NAVIGATION - STALL WARNING HORN REPLACEMENT

MODEL	SERIAL NUMBERS
335	335-0001 thru 335-0065
340	340-0001 thru 340-0555
340A	340A0001 thru 340A1817

MEB-34-06
Page 1 of 25

Figure 9. 335/340A Before Configuration 3 Modification (Sheet 1)

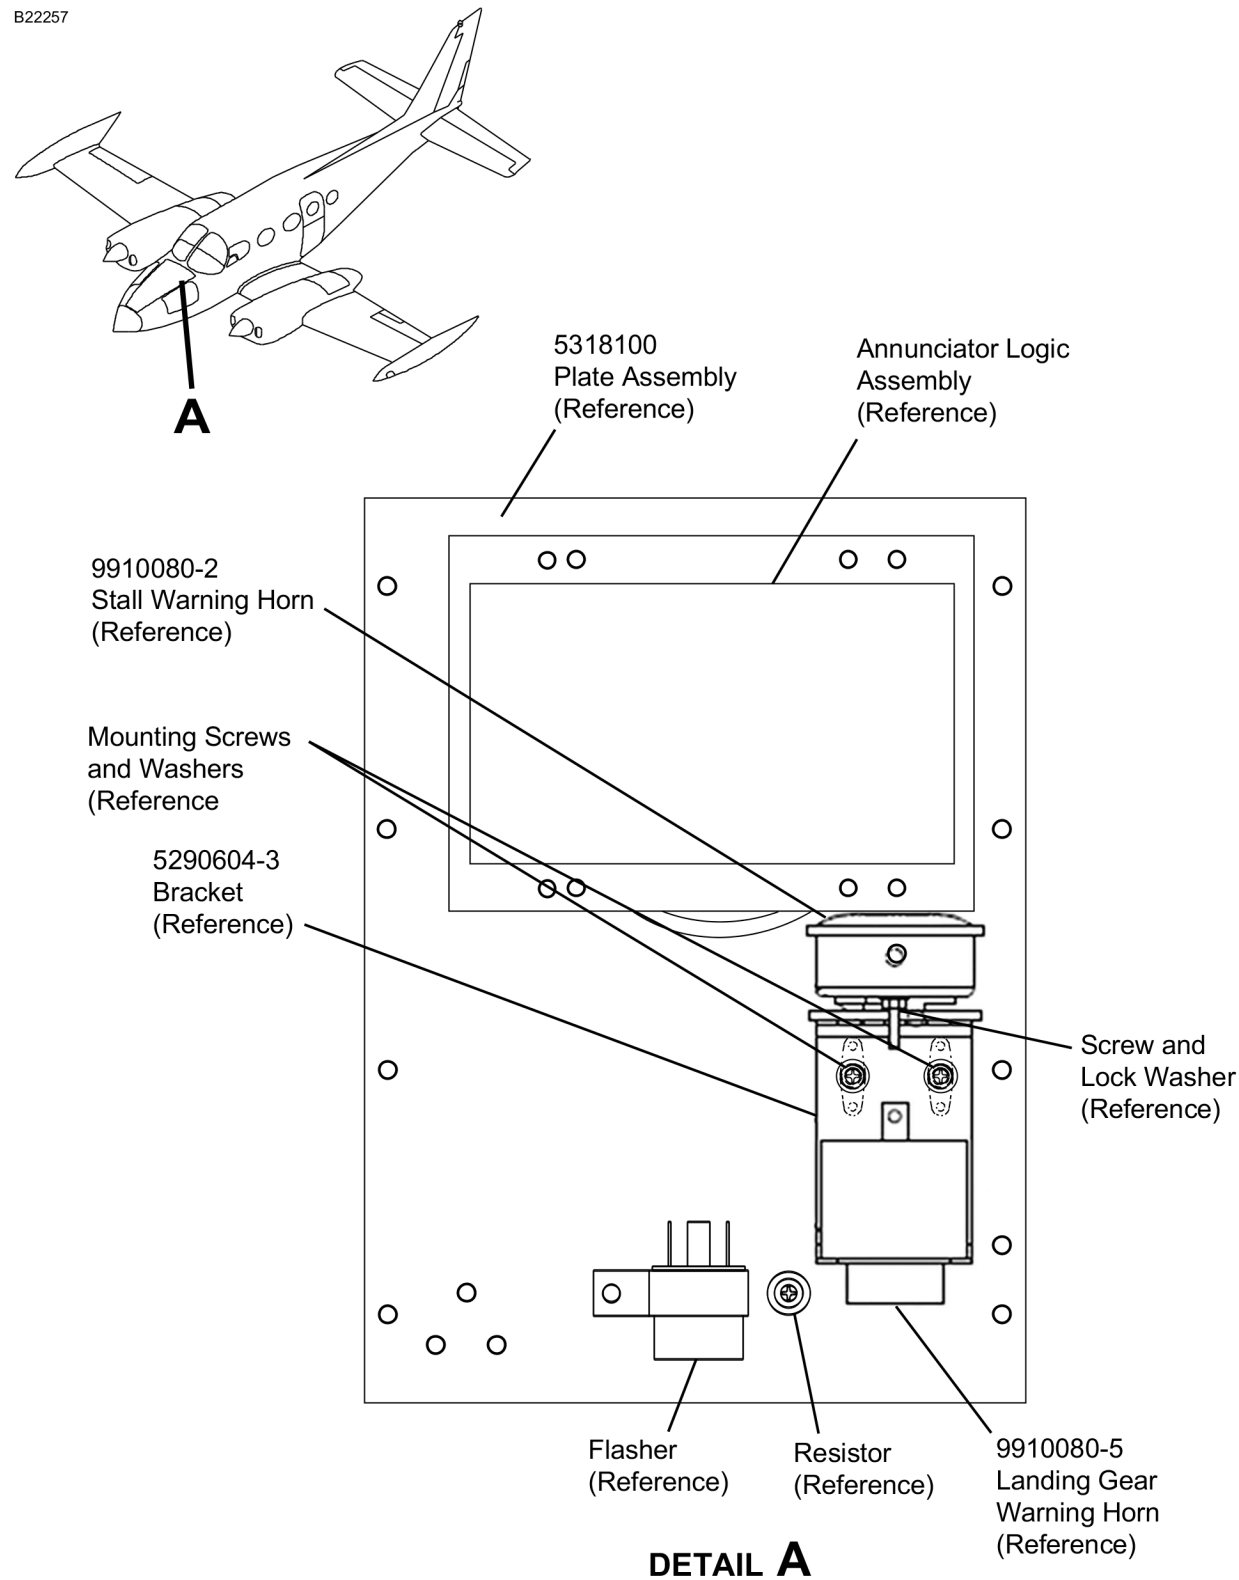
13. (For Model 340 Refer to Figure 7, Sheet 1, and for Model 335/340A Figure 9, Sheet 1.) Remove the 9910080-2 Stall Warning Horn as follows:

- A. Remove and discard the washer and lock screw from the 9910080-2 Stall Warning Horn.
- B. Disconnect and label the electrical wiring from the 9910080-2 Stall Warning Horn.
- C. Discard all electrical hardware from the 9910080-2 Stall Warning Horn.
- D. Discard the 9910080-2 Stall Warning Horn.
- E. Remove and keep the 9910080-5 Landing Gear Warning Horn.

Figure 10. 335/340A Configuration 3 (Sheet 1)

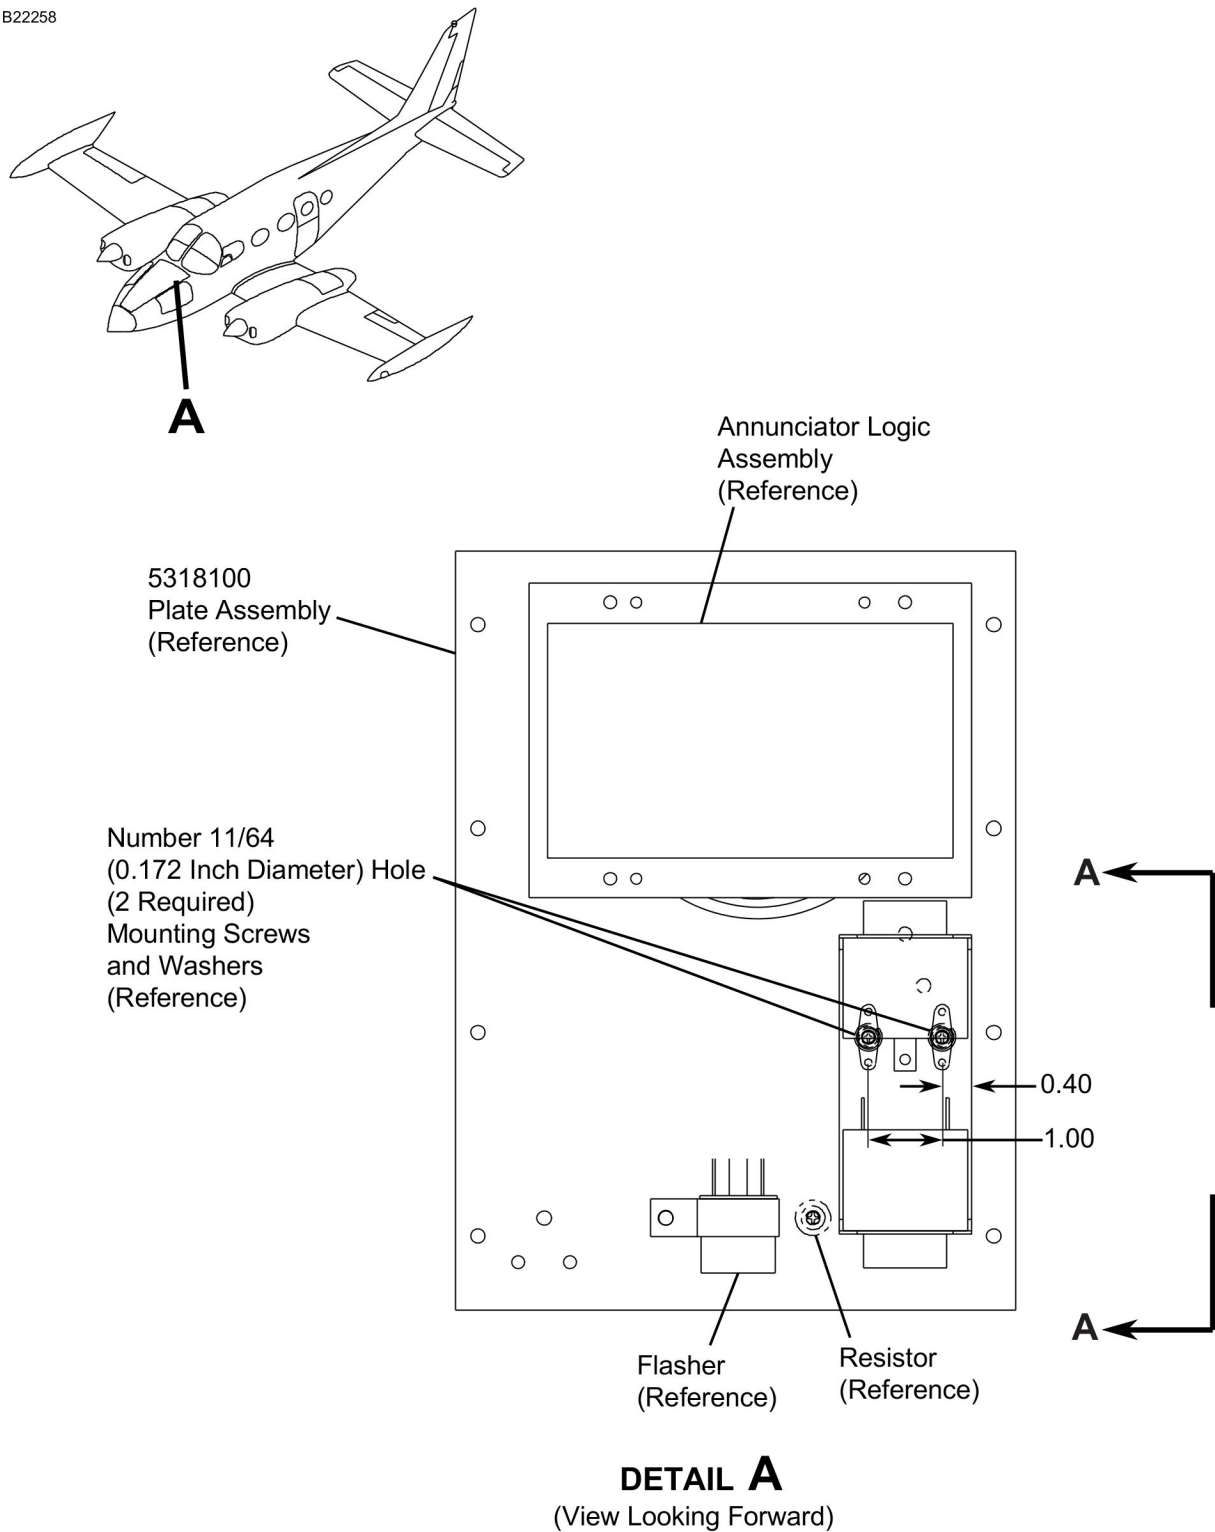
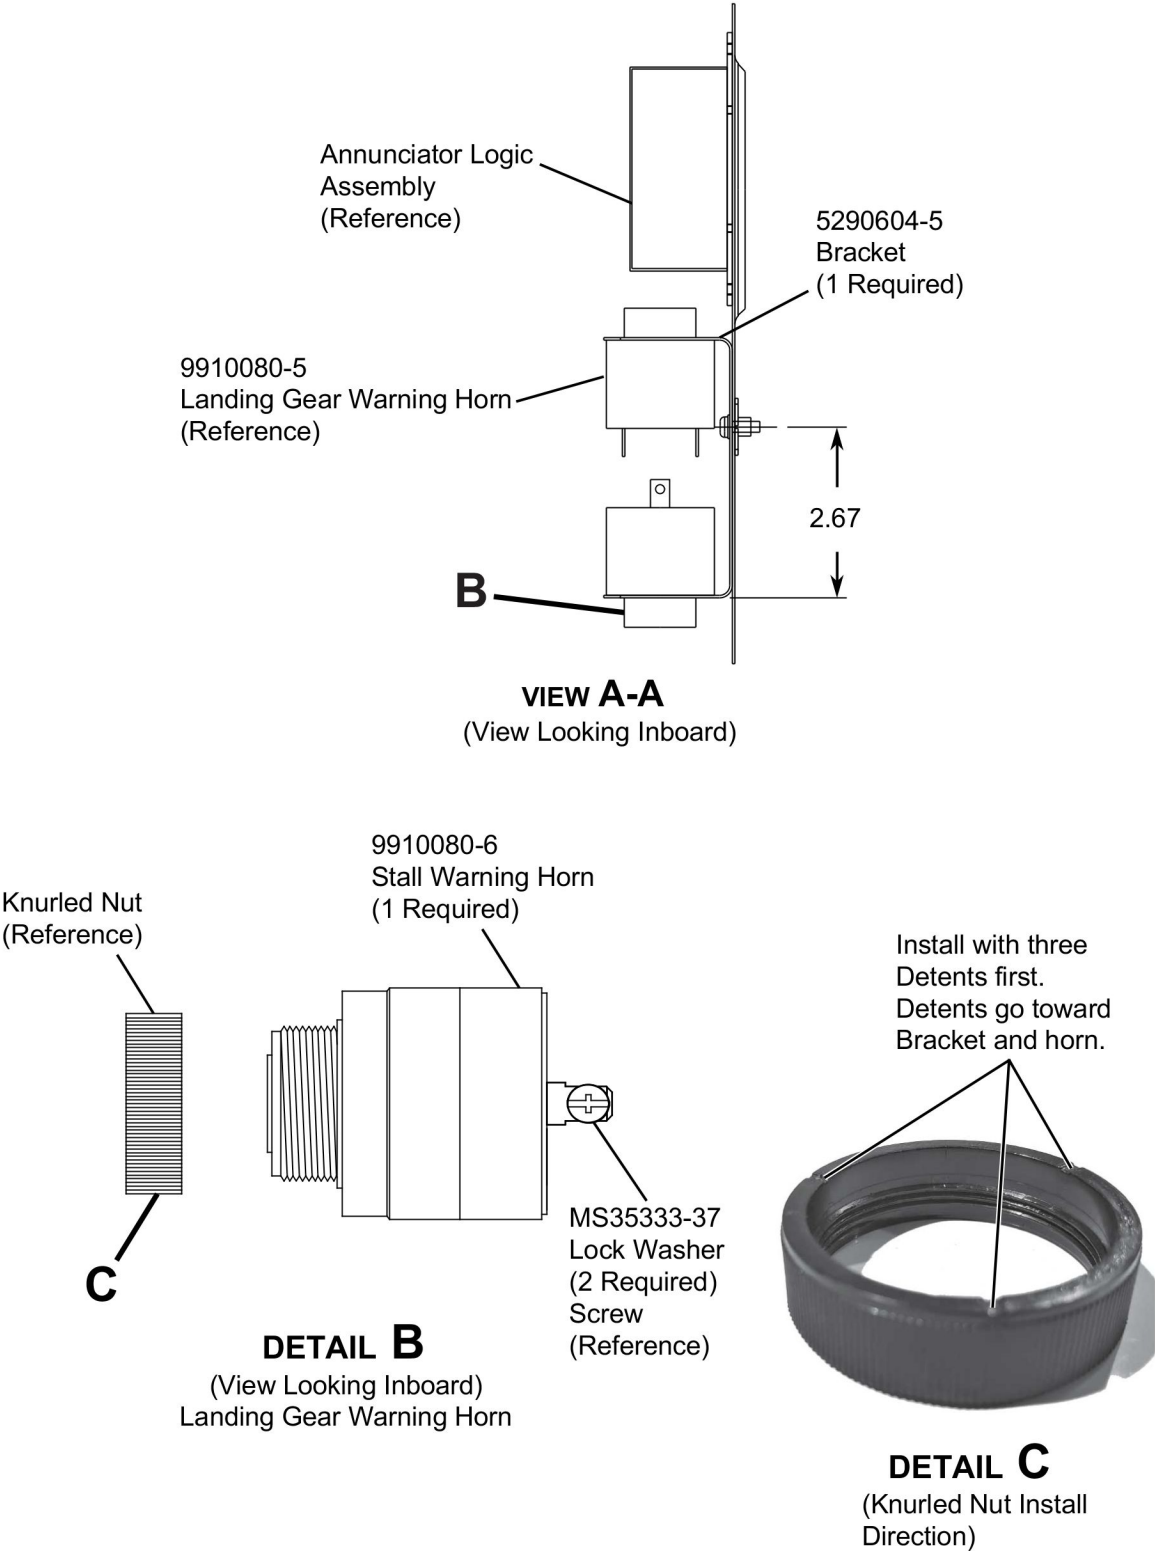
- G. Discard the 5290604-3 Bracket.
14. (For Model 340 Refer to Figure 8, Sheet 1 and 2, and for Model 335/340A Figure 10, Sheet 1 and 2.) Install the 9910080-6 Stall Warning Horn as follows:

- (4) Go to Step 14C.
- B. (For Model 335/340A airplanes.) Match drill the two Number 11/64 (0.172 inch diameter) holes of the 0818109 Support Assembly to the 5290604-5 Bracket.

- (1) Debur the drilled holes from the 5290604-5 Bracket.
 - (2) Apply Color Chemical Film Treatment to all bare metal.
 - (3) Install the 5290604-5 Bracket with the two kept mounting screws and the two kept washers into the 5318100 Plate Assembly.

- C. Install the 9910080-6 Stall Warning Horn into the 5290604-5 Bracket.
- D. Install the knurled nut onto the 9910080-6 Stall Warning Horn.
- NOTE:** The plastic knurled nut must be installed with the three indents toward the bracket and horn assembly. On the internal circumference, the smooth side without threads is installed first, towards the bracket and horn. This technique of installation will make sure the nut fully seats against the bracket and not bottom-out on the threads. If not installed correctly the knurled nut will bottom-out on the threads and the horn assembly will not be fully tightened in the bracket.
